# PCN - 20 004

Amphenol Information Communication and Commercial Products Group  
[www.amphenol-icc.com](http://www.amphenol-icc.com)

<b>Product Name:</b>	Mini USB		
	HPL 511		
<b>Product Manager:</b>	Tracy Zhou		
<b>Subject:</b>	Notification of Planned Change		
<b>Distribution:</b>	Affected Customers		
<b>Type of Change:</b>	Design Change		
<b>Change Description:</b>	<p>Design change for 10119313 product series. PCB layout remains same and some difference on appearance</p> <div style="display: flex; justify-content: space-around; align-items: flex-start;"> <div style="text-align: center;">               Old         </div> <div style="text-align: center;">               New         </div> <div style="text-align: center;">               Old         </div> <div style="text-align: center;">               New         </div> </div> <p style="margin-left: 100px;">1. Slight difference on shape of dovetail groove                  2. Slight difference on bottom of housing</p> <p style="margin-left: 350px;">1. Slight difference on side of shell shape                  2. Slight difference on housing shape</p>

10119313 design change

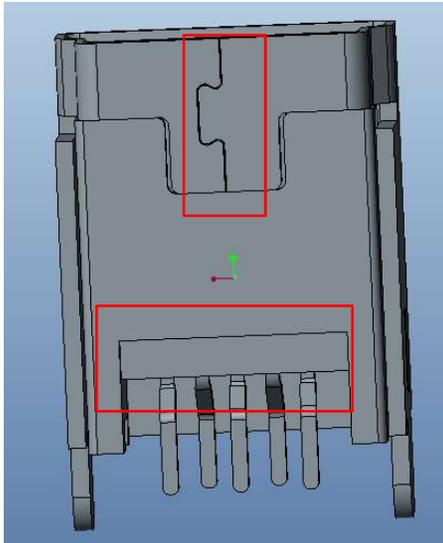
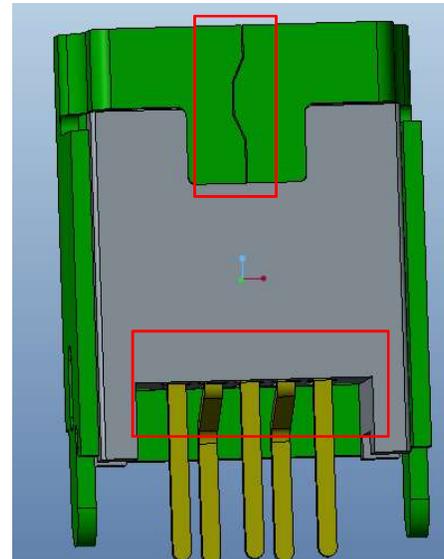
1. Slight difference on shape of dovetail groove
2. Slight difference on bottom of housing

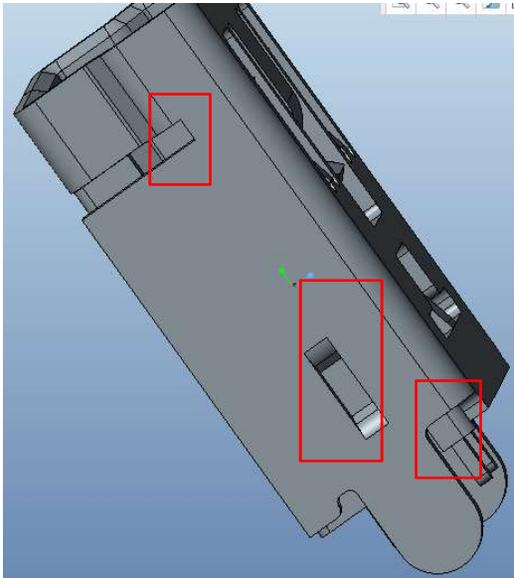
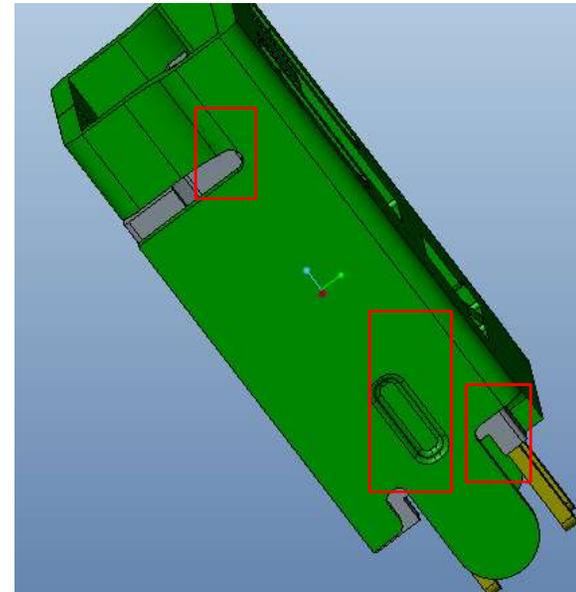
- 1.Slight difference on side of shell shape
- 2.Slight difference on housing shape
